**STAFF REPORT
KETCHUM PLANNING AND ZONING COMMISSION
SPECIAL MEETING OF SEPTEMBER 21, 2021**

PROJECT: Waddell-Roush Duplex Hot Tubs

FILE NUMBER: P21-068

APPLICATION TYPE: Amendment to Design Review Approval

LANDSCAPE PLAN

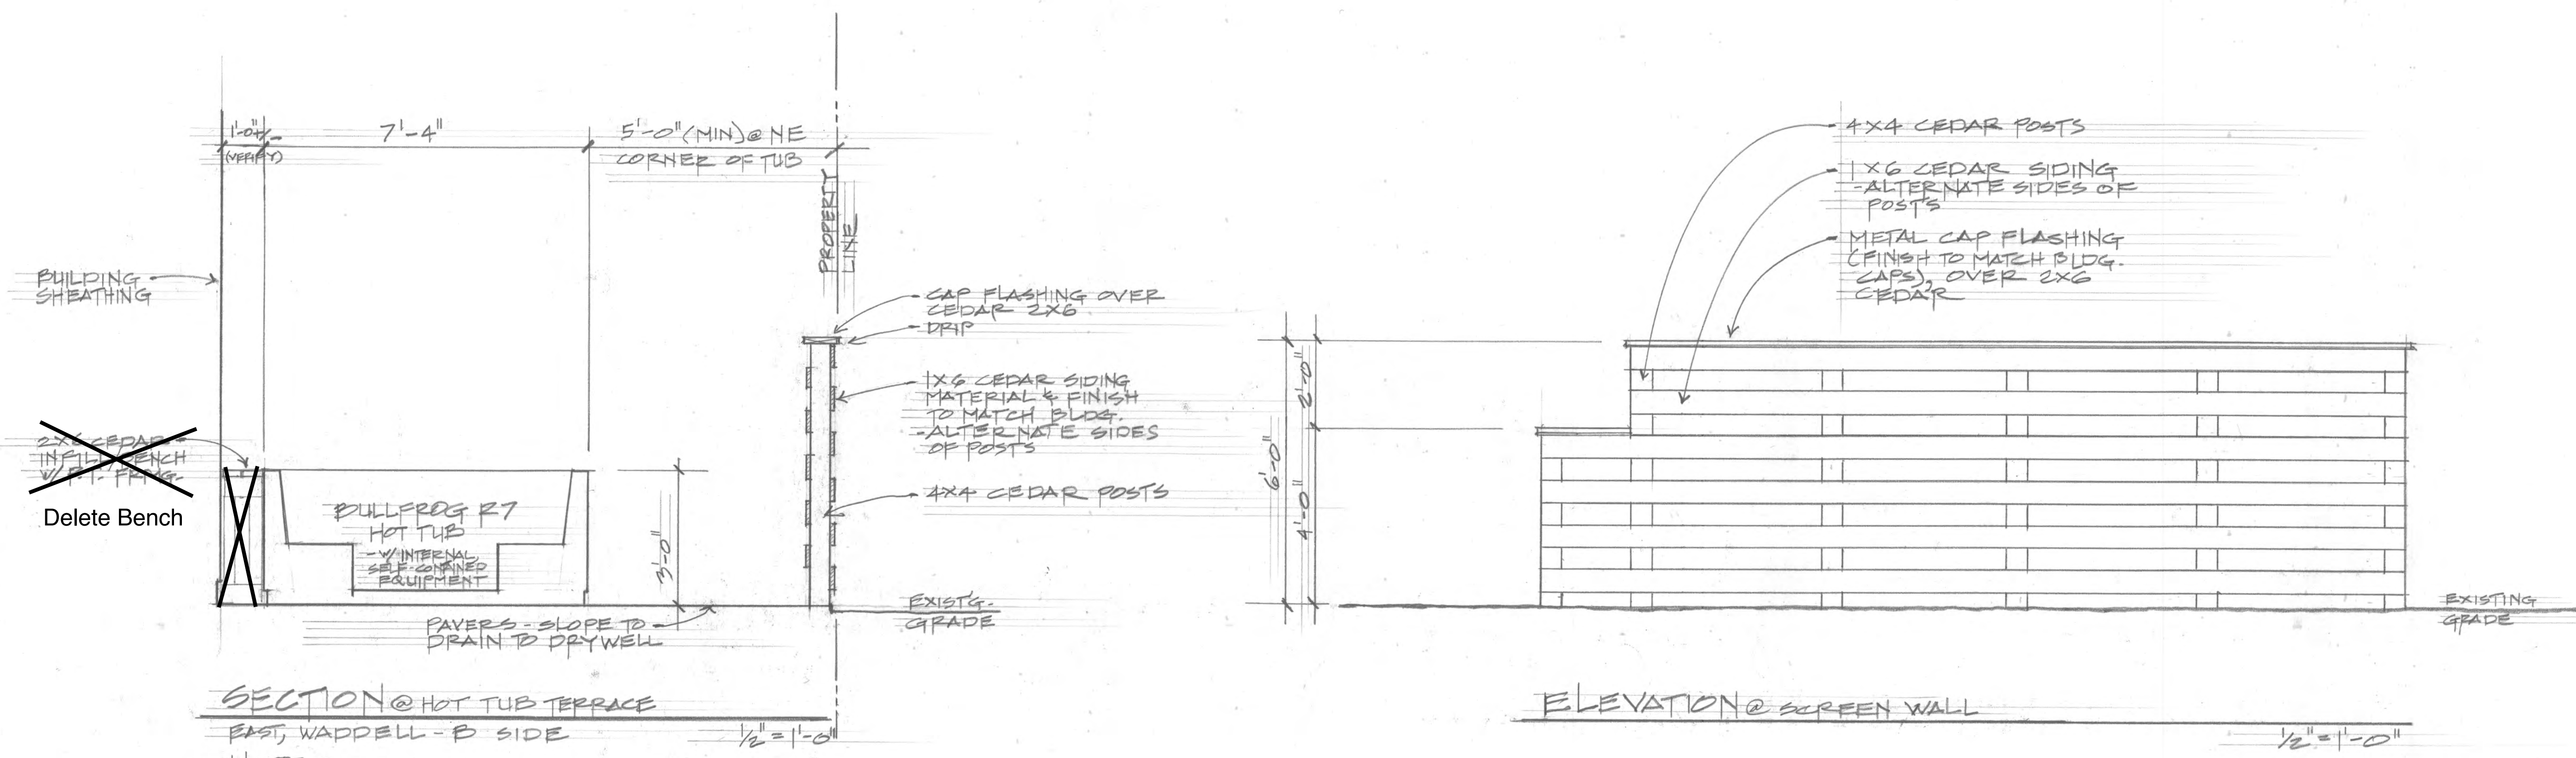
The applicant has submitted updated drawings proposing exterior modifications from the project plans approved with Design Review P20-031. The project plans are attached as Exhibit A to the staff report. The proposed amendments to the design review approval include the addition of two hot tubs for each townhouse unit within the duplex. The proposed hot tubs are located within the east and west side yard setback areas and sited on new paver patios. Exterior modifications also include the addition of new doors at the east and west side facades to access the new hot tubs. The east side hot tub is proposed to be screened with 6- and 4-foot-tall cedar fence panels. An elevation of the proposed screening is provided on Sheet L-03 of the project plans. The west side hot tub is proposed to be screened by landscaping, including Redtwig Dogwood.

The siting of the hot tubs proposed for the Waddell-Rousch development encroaches within the side yard area required for the principal, duplex building. The setback from side property lines required in the GR-L Zone is 1 foot for every 3 feet in building height or a minimum of 5 feet. Both hot tubs are sited within the duplex's 11-foot-8-inch required side yard setback area. The east townhome unit's hot tub is proposed to be sited 5 feet from the side property line. The west townhome unit's hot tub is

proposed to be sited 7 feet 6 inches from the property line. While sited within the duplex's side yard setback areas, the hot tubs meet the minimum 5-foot setback required from side property lines in the GR-L Zone.

Staff recommends that the Commission direct the applicant to relocate the proposed hot tubs to the rear of the duplex development outside of the rear yard setback area.

SECTION @ HOT TUB TERRACE
EAST, WADDELL - B SIDE
1/2" = 1'-0"

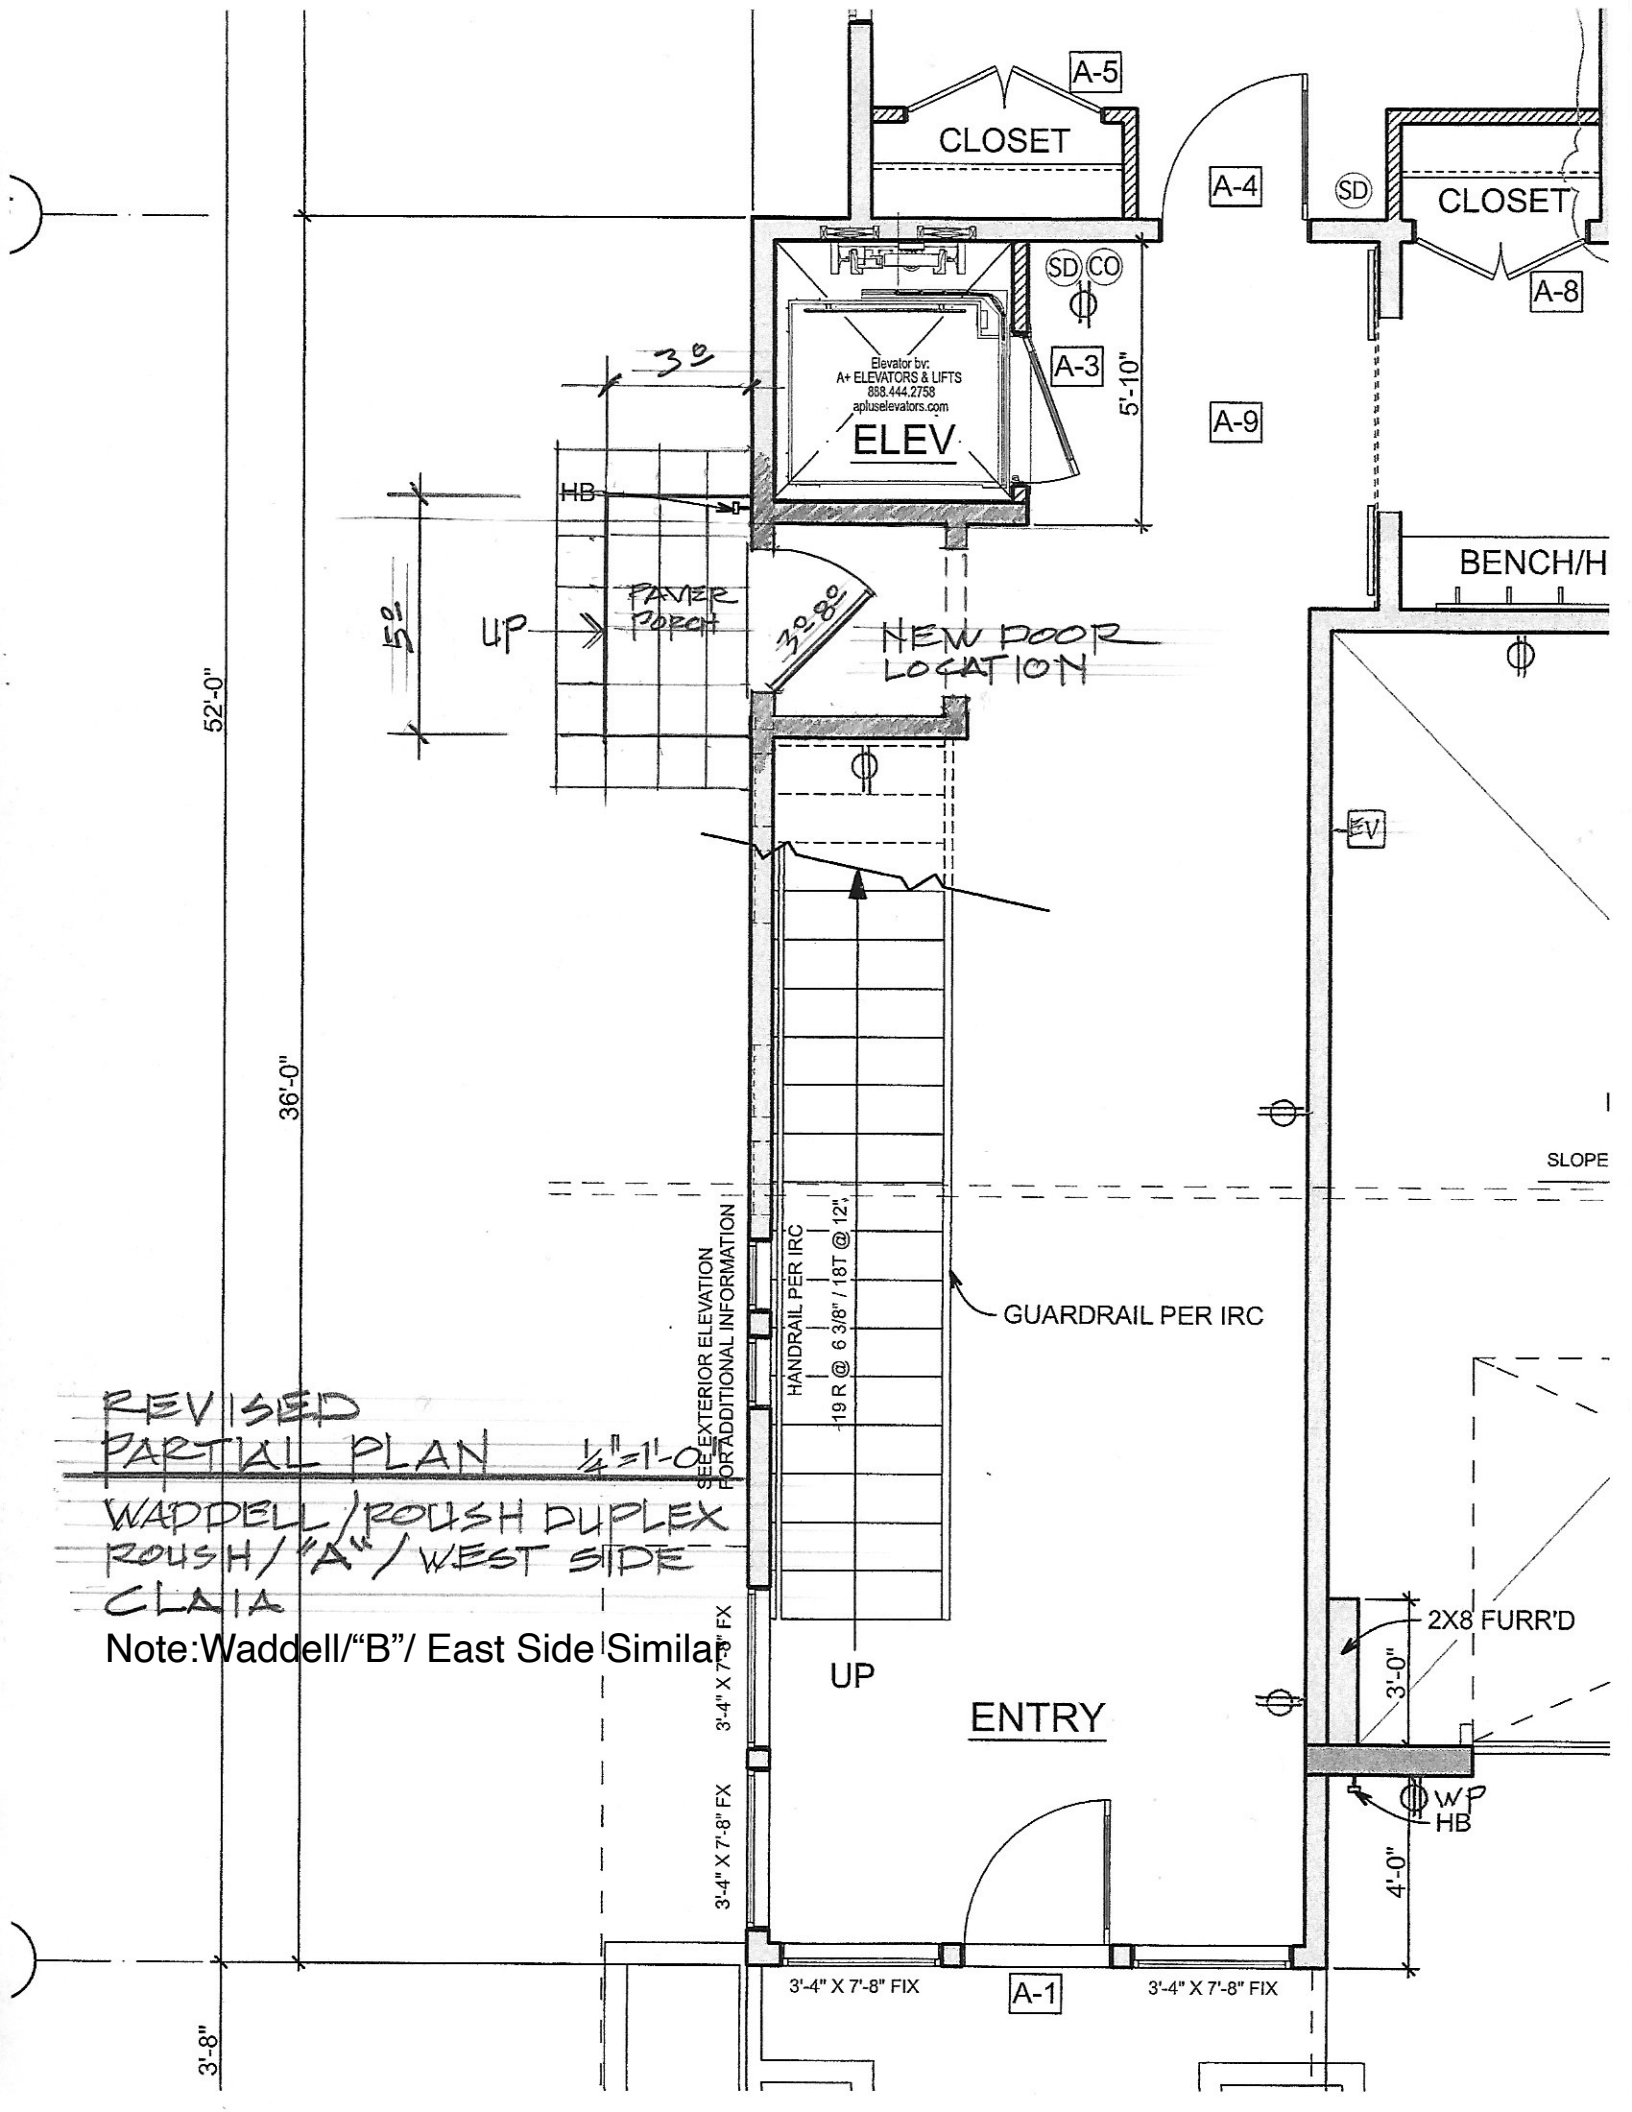
The applicant has provided specifications for the proposed hot tubs that are included the project plans attached as Exhibit A. A section of the hot tub is provided on Sheet L-03. The hot tubs are 3 feet tall. Notes on Sheets L-01 and L-03 indicate the hot tubs are non-permanent features that are self-contained with internal equipment. The hot tubs will be placed on the new paver patio but not permanently attached to the patio. These hot tubs will be connected to the development site through their mechanical, electrical, and plumbing systems.
